UNITED STATES PATENT AND TRADEMARK OFFICE

Office Action Summary

10/623,843

DETAILED ACTION

FIG 2b

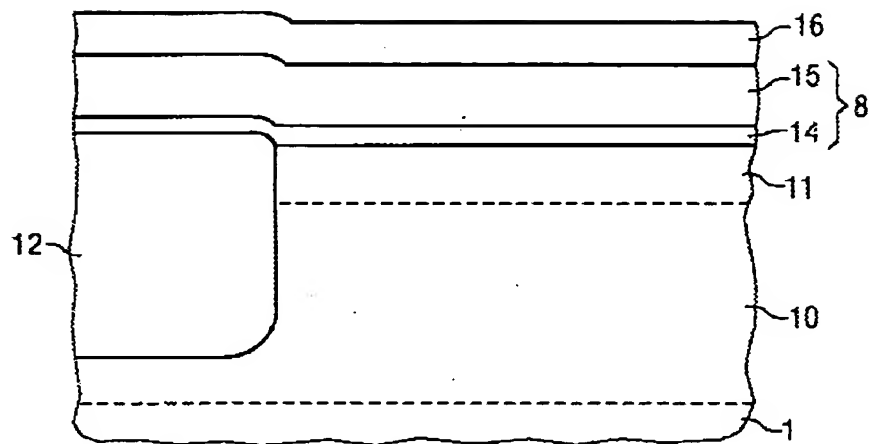
In re claim 1, Palm discloses a method for fabricating a buried bit line for a semiconductor memory, which comprises: producing strip-like doped regions parallel to and at distances from one another in a semiconductor body 1, the regions being adapted to act as bit lines and as source/drain regions (3, 4) of a respective memory transistor (col. 5, line 47 to col. 6, line 19 and FIGS. 2b and 3);

FIG 3

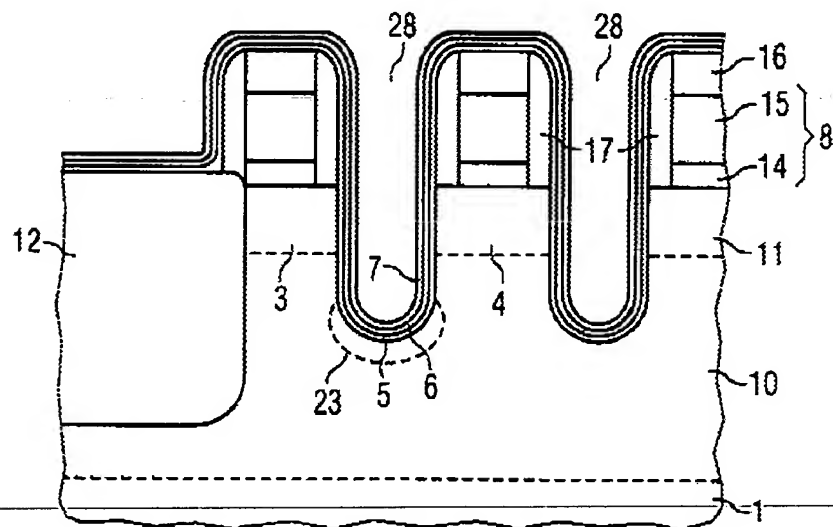
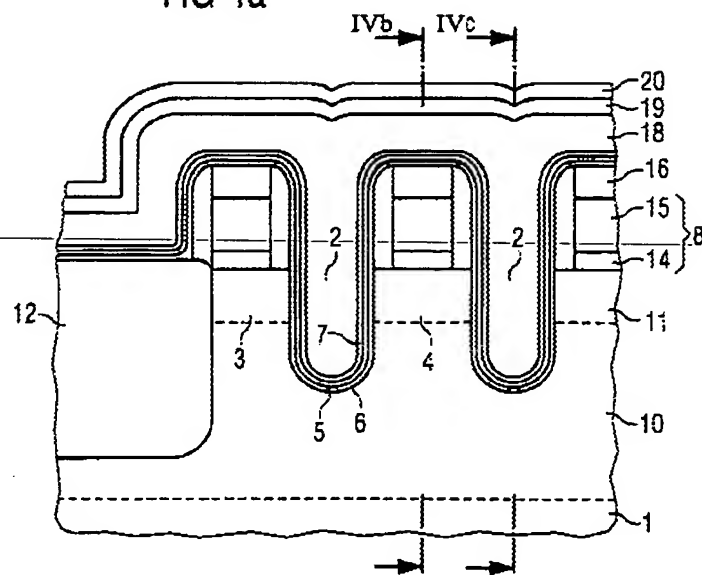
applying laterally with respect to the doped regions, in each case, one layer sequence adapted to act as a gate dielectric (ONO layer) and including a lower boundary layer 5, a storage layer 6, and an upper boundary layer 7 (col. 6, lines 20-32 and FIG. 3);

removing the sacrificial layer (col. 5, line 60 to col. 6, line 19); and producing the upper boundary layer 7 on the storage layer 6 and oxidizing at least a proportion of the polysilicon to form the oxide region 29 (col. 9, lines 9-46 and FIG. 3.3c).
